From: Wold Architects and Engineers

Date: March 23, 2015

Subject: Addendum No. 1 for Bidding Documents for the: Madonna University Toilet Renovation

Livonia, Michigan

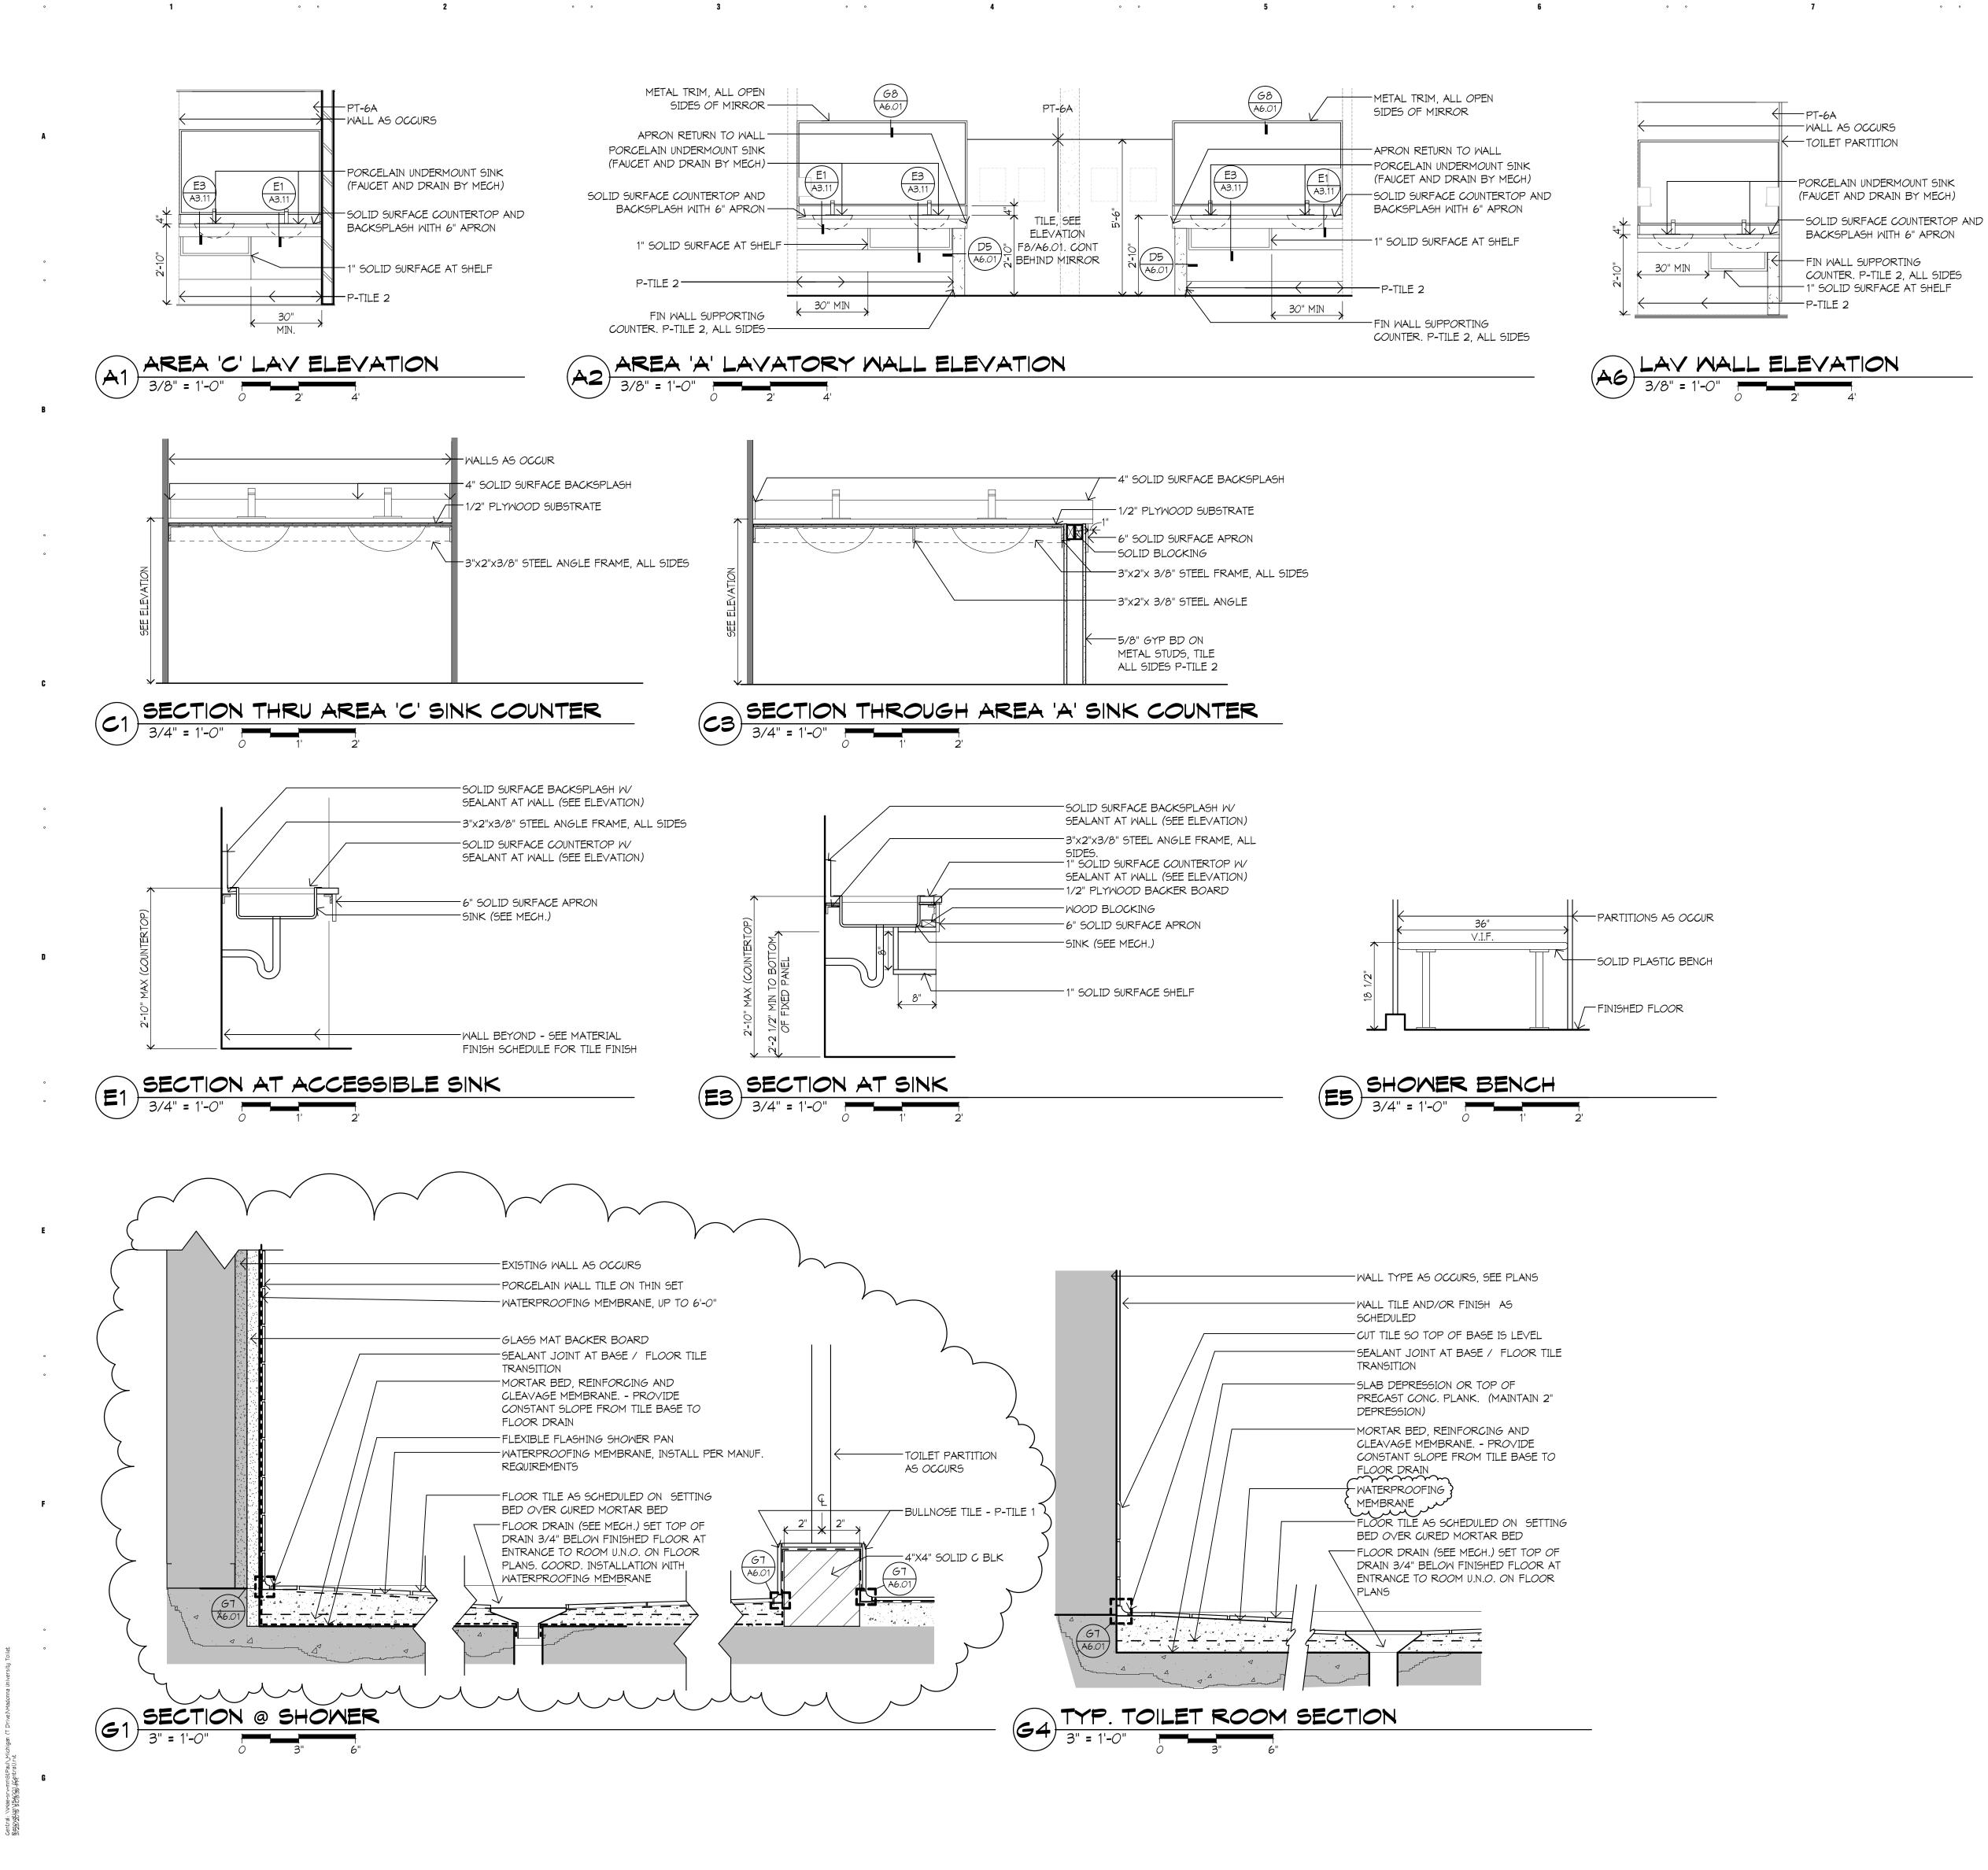
- A. Existing hollow metal frames at new doors are to remain, refer to reissued sheet A6.01. All existing frames are to be primed and painted per specifications.
- B. At the MATERIAL FINISH / COLOR SCHDEULE, omit specification section 10 20 00 TOILET ACCESSORIES.
- C. At the MATERIAL FINISH / COLOR SCHDEULE, add the following at SPECIFICAITON SECTION 09 30 00 TILF:
 - "Porcelain Floor Tile -2 (At showers and thresholds), Crossville, Series/Color: Cross-Tread, Terra Rosata"
- D. At detail G7/A6.01 provide sealant joint between tile and metal trim piece.

INTERIOR **ELEVATIONS AND DETAILS**

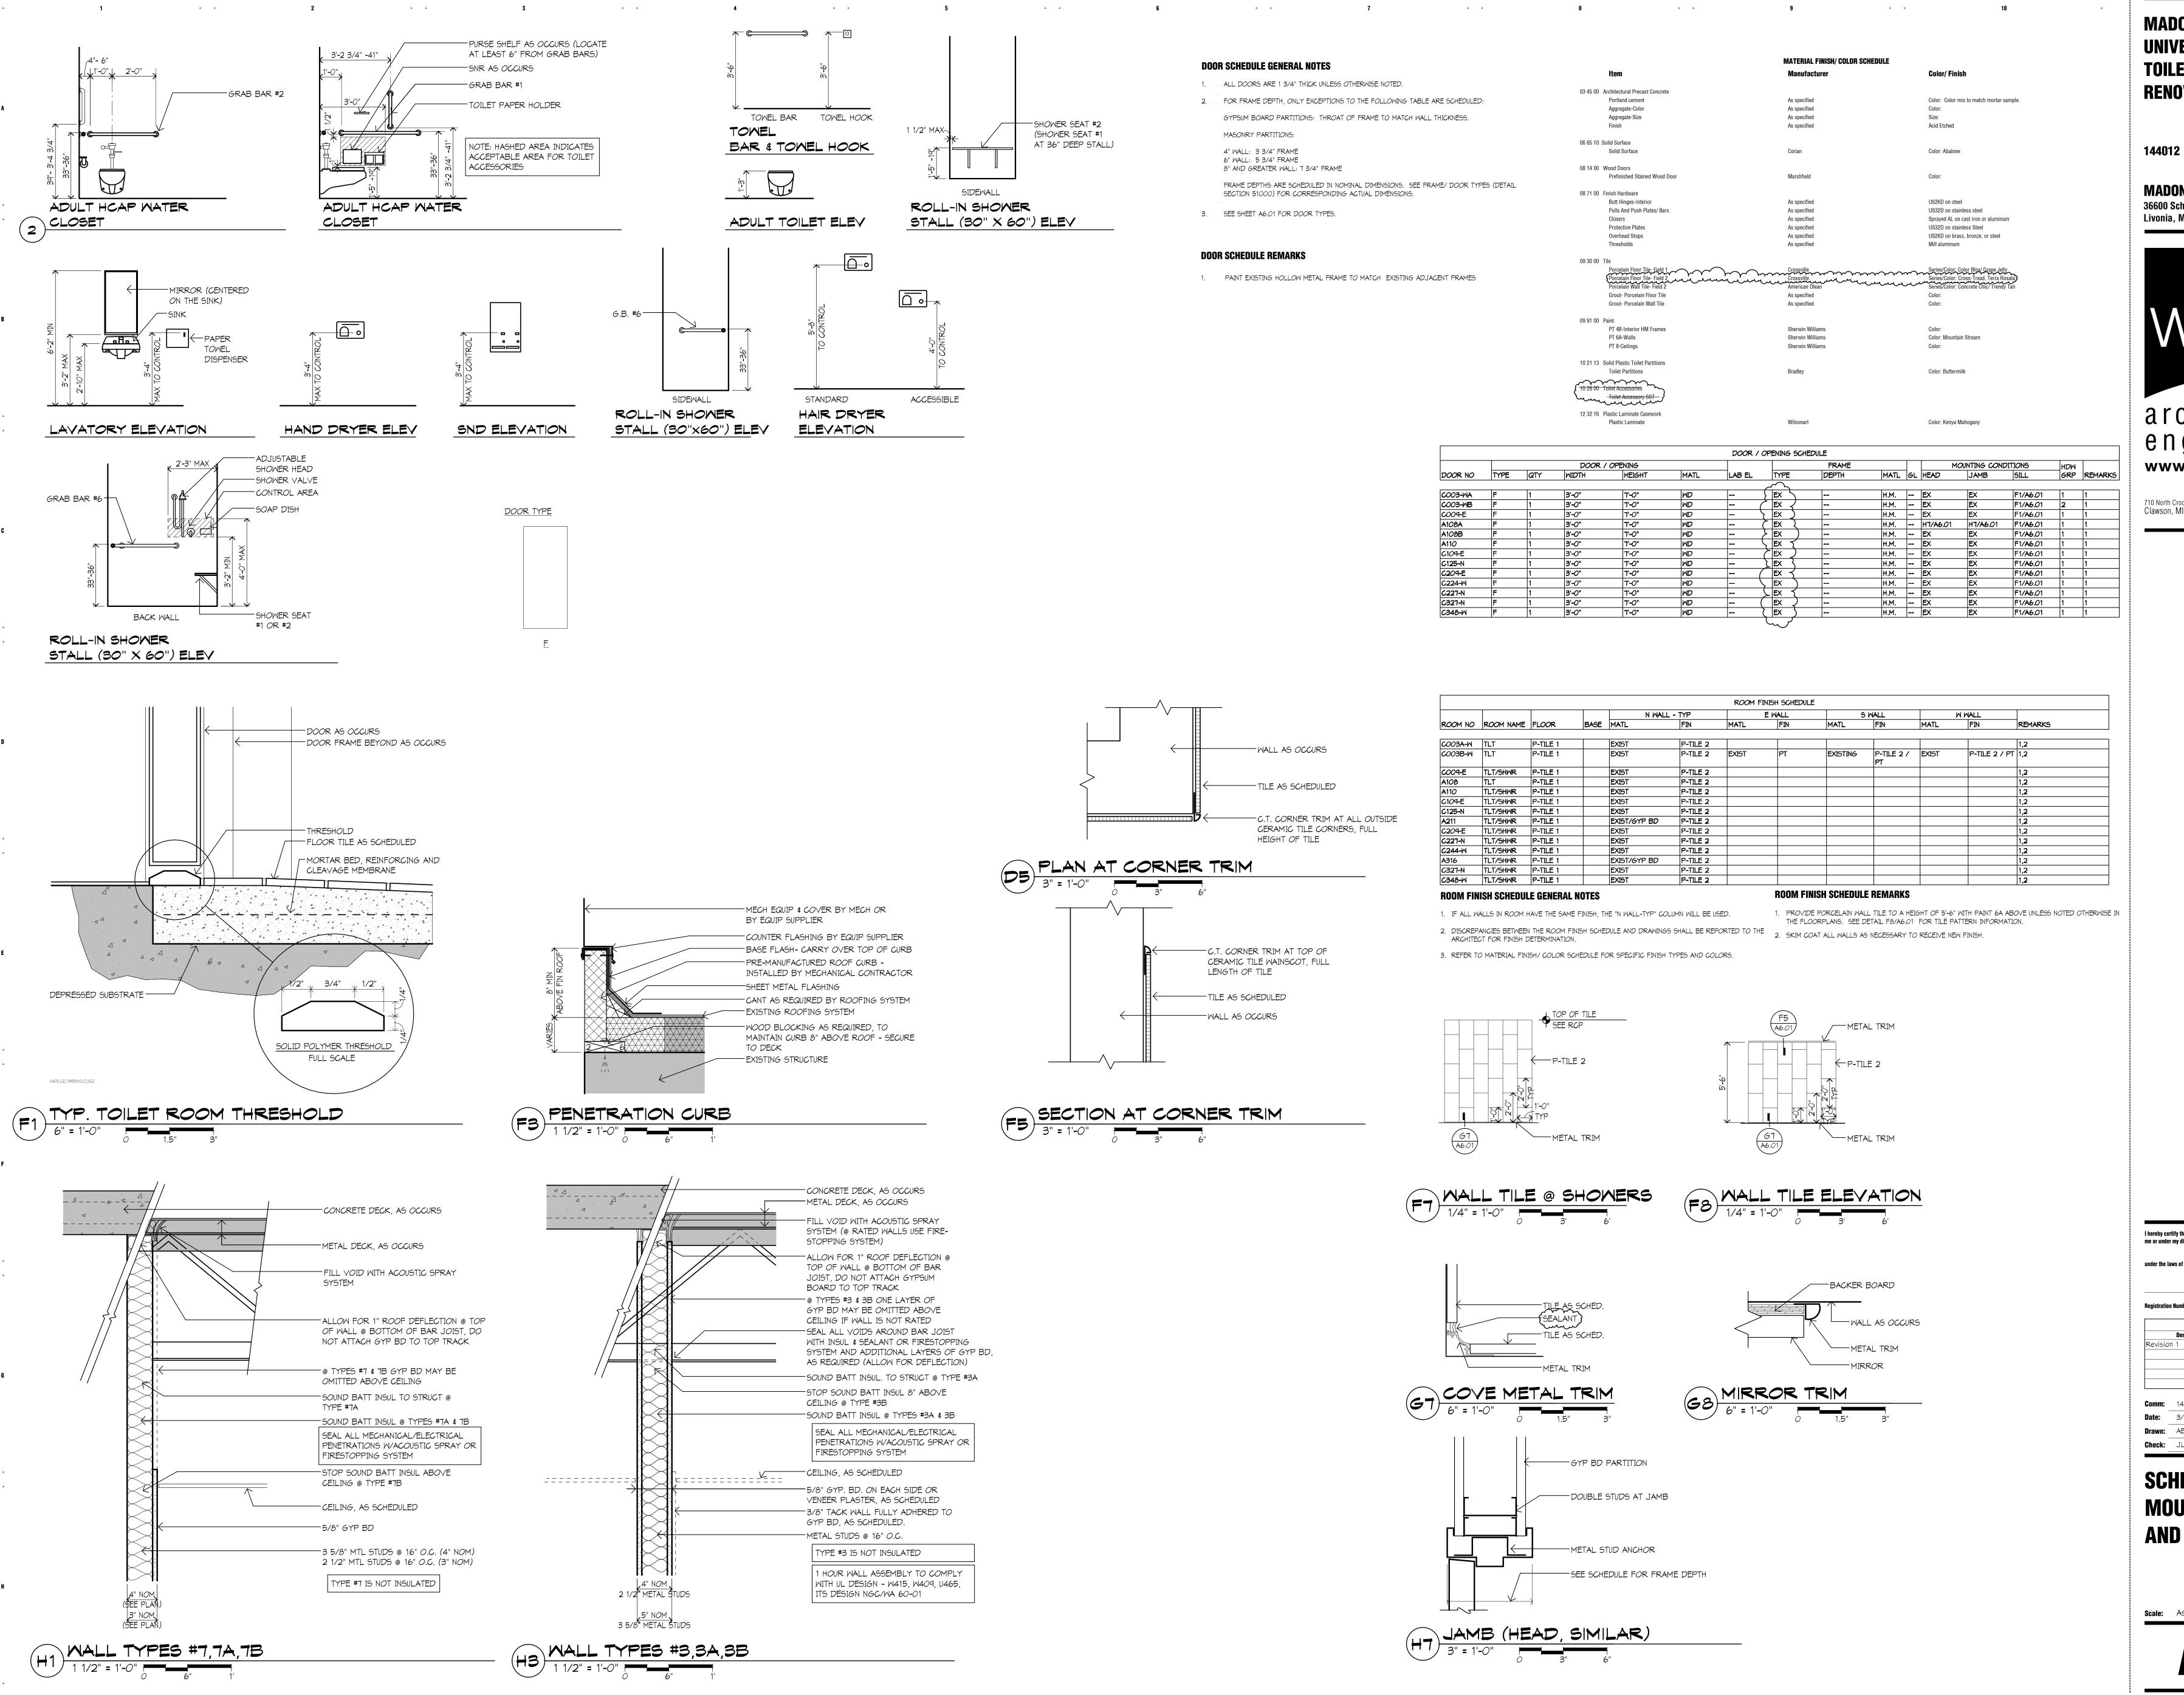
- A. Refer to reissued drawings sheet A3.11, revise details G1- SECTION @ SHOWER and G4-TYP. TOILET ROOM per attached.
- B. Detail G1/A3.11 is TYPICAL at all shower locations. At H.CAP showers provide floor slopes that meet accessibility code in lieu of raised threshold per standard showers.

EXHAUST DEMOLITION DETAIL

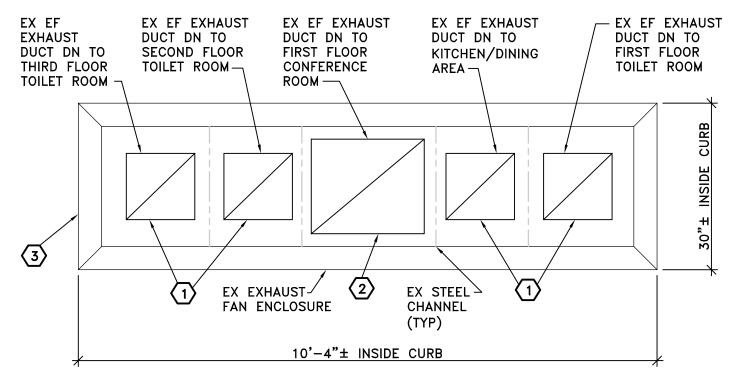
Demolish existing roof curb, exhaust fans, steel support channel, existing motorized dampers, actuator and associated wiring for ability to install new exhaust fans. Five existing exhaust fans are under one exhaust enclosure. The entire existing enclosure and roof curb shall be removed. See attached sketch R1/M1.1. Field verify all existing sizes.

- 1) REMOVE EXISTING EXHAUST FAN, DUCTWORK AND MOTORIZED DAMPER AS NECESSARY TO INSTALL NEW ROOF CURB AND EXHAUST FAN.
- (2) REMOVE EXISTING EXHAUST FAN, DUCTWORK AND MOTORIZED DAMPER AND CAP EXHAUST DUCTWORK BELOW ROOF.
- REMOVE EXISTING ROOF CURB AND EXHAUST FAN ENCLOSURE FOR ABILITY TO INSTALL NEW EXHAUST FANS. REFER TO ARCHITECTURAL FOR ALL ROOF WORK. COORDINATE EXACT SIZE OF DUCTWORK AND ENCLOSURE IN FIELD.
